Service Bulletin

Model : GP605

No.: GP605-008
(FF-T01-K1-000018-01)

Subject : COUNTERMEASURES FOR GEAR BREAKAGE DUE TO FALLING TIE-WRAP

Fig. 1

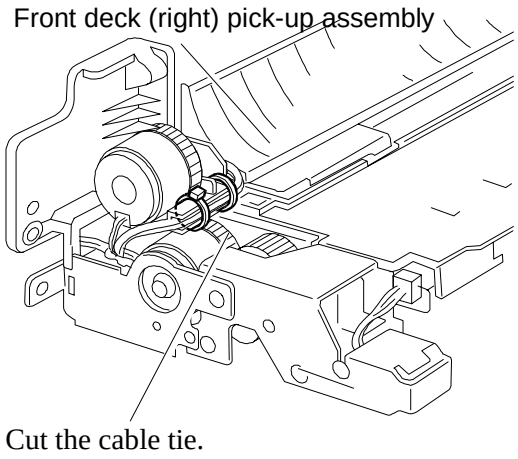
<Cause>
When the fixing/feeder frame assembly is drawn in and out, tight space inside the machine causes the cable tie which holds the front deck (right) pick up assembly cables to make contact and gets cut. The cut cable tie falls into the front deck (right) gear and the gear drive locks, causing the weakest 20T/32T gear (Parts Catalog FY8-31DU-010 P260-2) in the paper pick-up drive assembly to break.

<Factory measure>
The cable guide was cut, and the cables are held in place by freeing the cable tie from its former position.

1) Remove the front deck (right) pick-up assembly.
   (See Service Manual FY8-13FE-000 P7-53.)
2) Cut the cable tie (Fig.1).
3) Accomplish reattachment by following the procedure in reverse.
